<b>TO:</b>	<b>CHAIR AND MEMBERS – PLANNING AND ENVIROMENT COMMITTEE MEETING</b>
<b>FROM:</b>	<b>GEORGE KOTSIFAS DIRECTOR OF BUILDING CONTROLS AND CHIEF BUILDING OFFICIAL</b>
<b>SUBJECT:</b>	<b>APPLICATION BY: 1830150 ONTARIO LIMITED 580 FANSHAWE PARK ROAD EAST PUBLIC SITE PLAN MEETING MARCH 26, 2012 after 4:15 PM</b>

The purpose of this application is to obtain site plan approval for the construction of a 1 storey, 566.15m<sup>2</sup>, multi-unit commercial building with a drive-through on lands known municipally as 580 Fanshawe Park Road East. The application for site plan approval has been made to ensure the development takes a form compatible with adjacent land uses.

Proposed South and East Elevations

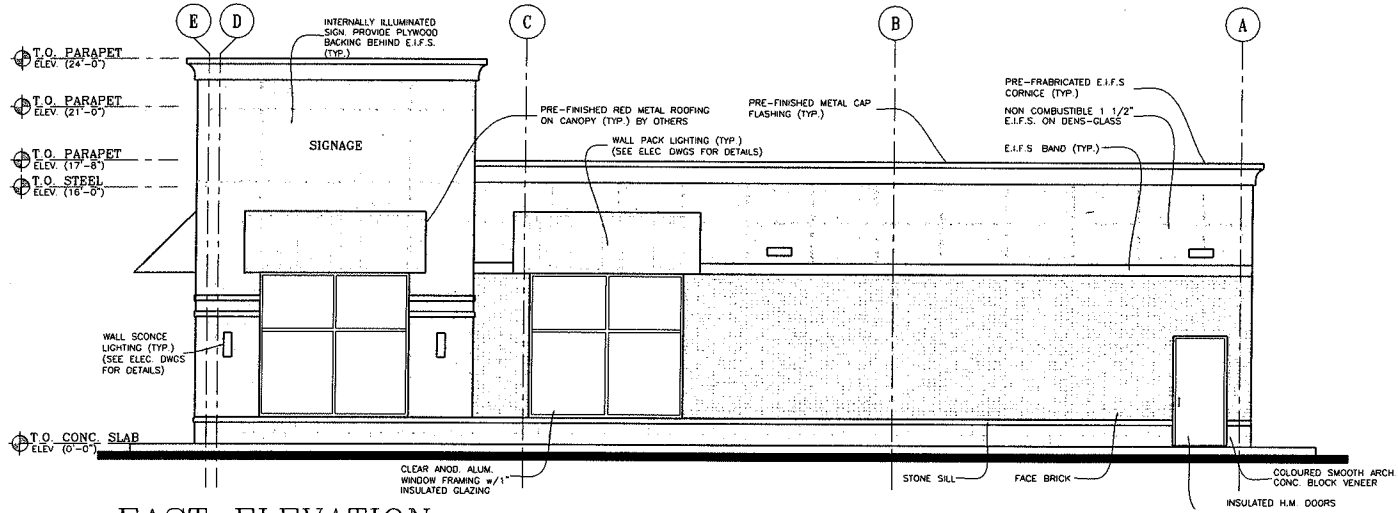
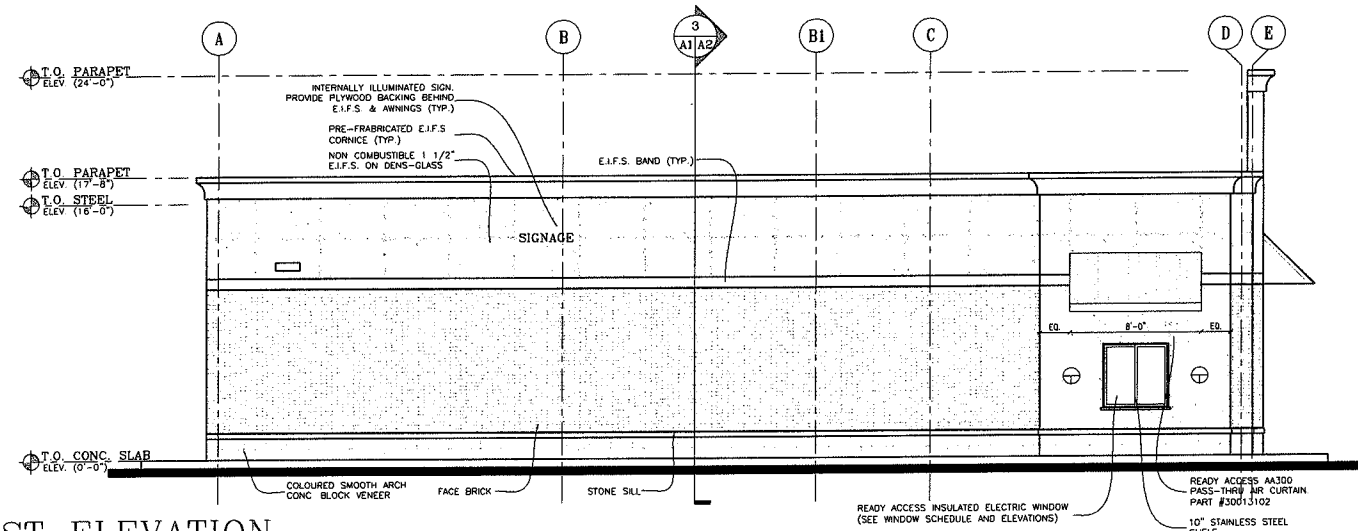
Through the site plan consultation meetings, the Community Planning and Urban Design Department provided comments on the building elevations which include the requirement to clearly establish a hierarchy to the unit entrances. It was suggested this could be achieved by providing a canopy used consistently in the development over the principal entrance of each unit which the applicant was able to accommodate and the elevations have subsequently been approved.

Proposed Landscape Plan

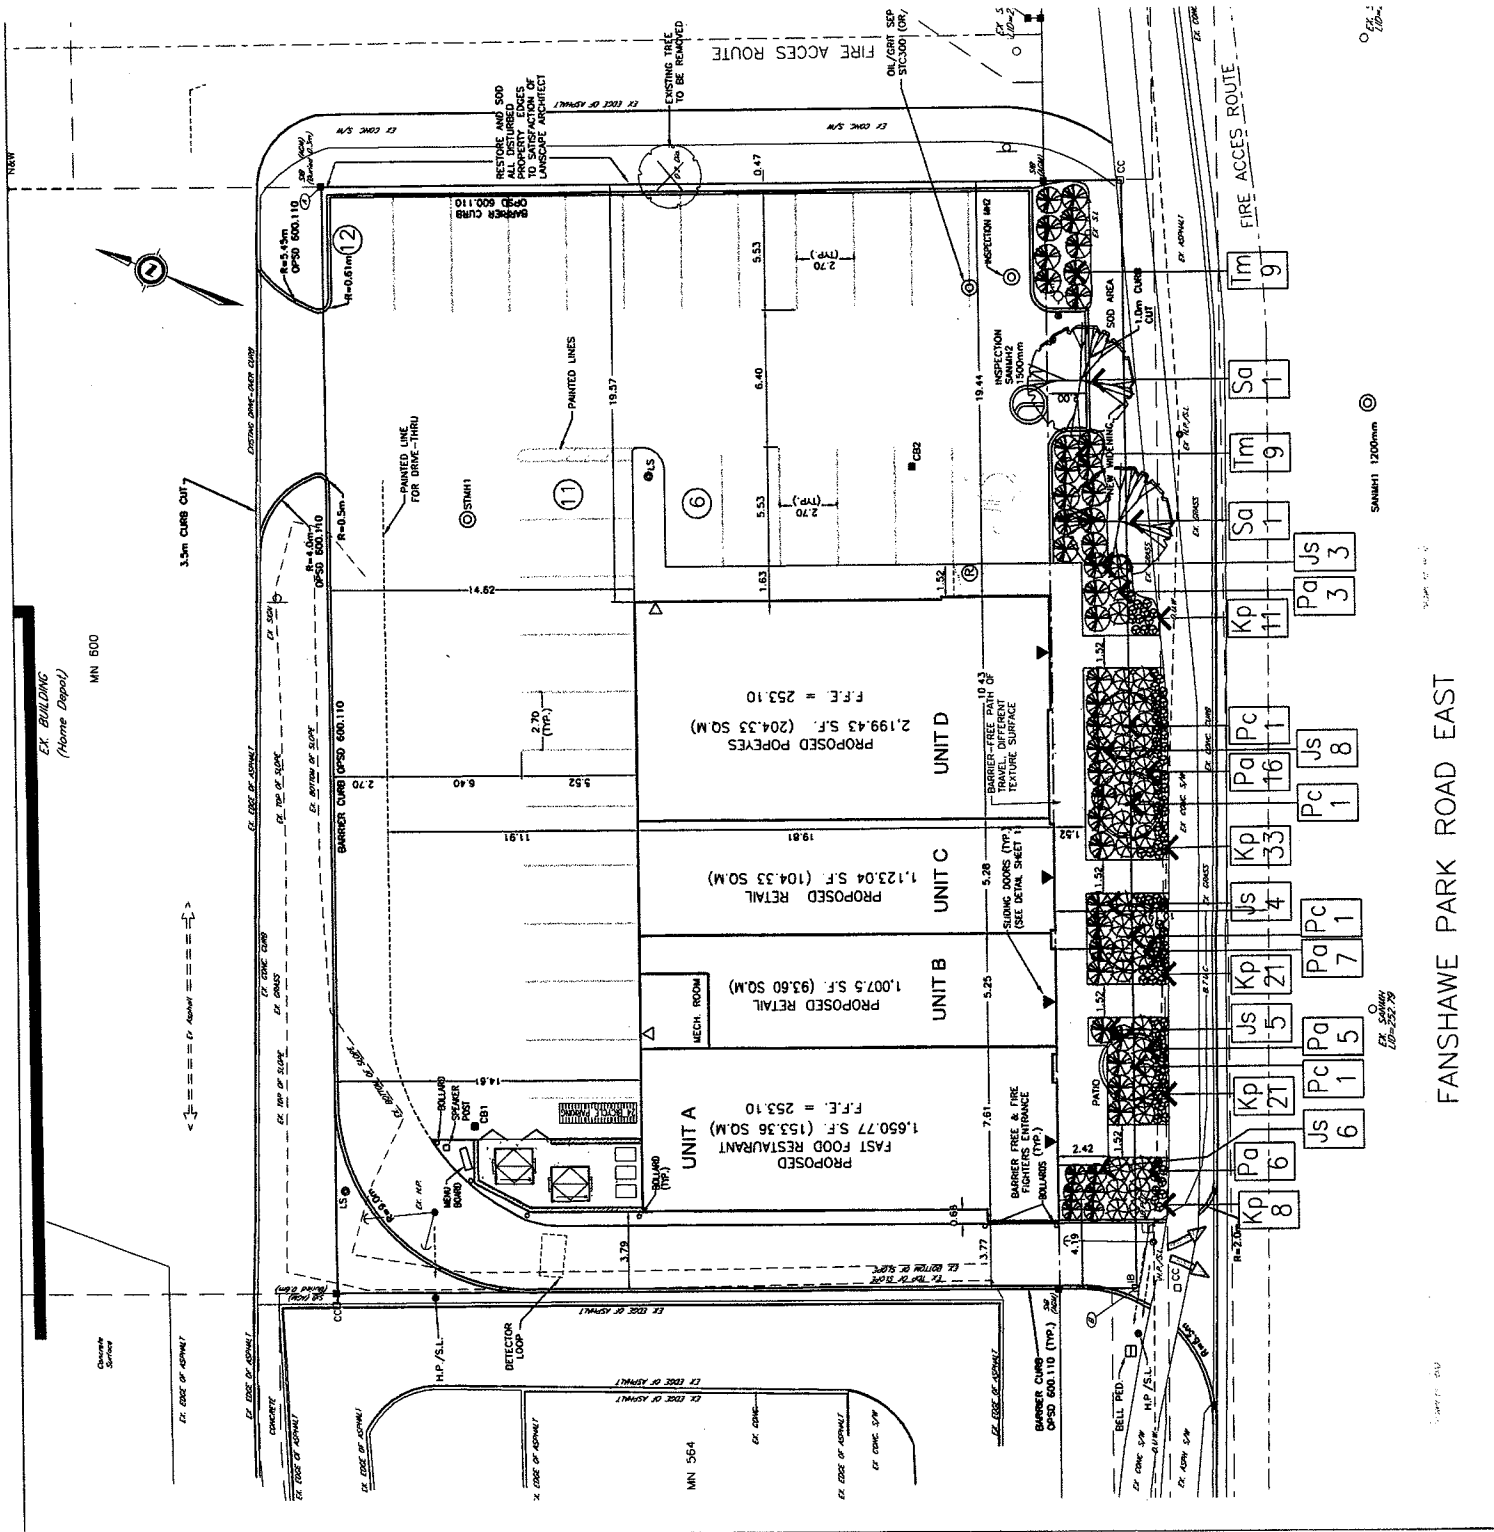
Along the rear of the proposed building is a proposal for 11 parking spaces (including one small car parking only designated space), the bicycle parking spaces, and the garbage enclosure. The parking spaces comply with the required minimum sizes however there is no buffer between the building and the parking stalls which could result in vehicles running into the building and conflict with pedestrians trying to access the mechanical room door along this elevation of the building. There is no opportunity to add a sidewalk because it would shift the parking to the north and the driveway width of 6.4 m is already our less than the Site Plan Guideline requirement of 6.7 m.

Through the site plan consultation meeting, Development Services and Urban Design indicated that a buffer consisting of a sidewalk, curb stops, or planter islands would be required to provide protection to the building and pedestrians using this space. The current proposal causes individuals using these parking spaces, or employees carrying garbage or recycling material to the enclosure, to walk behind the parked cars potentially creating a conflict. The small car parking only designated parking space in this line of parking will not function for a larger vehicle or SUV as there is not enough manoeuvrability for larger vehicles to avoid crossing into the drive-through.

- Obtain easements and licensing agreements as required for the items located in the City's road widening allowance.
- Provide additional landscape material (tree(s), shrubs, and/or groundcovers) in the northwest corner of the property opposite the drive-through and shift the proposed deciduous tree south and out of the car turnaround in the City's road widening allowance.
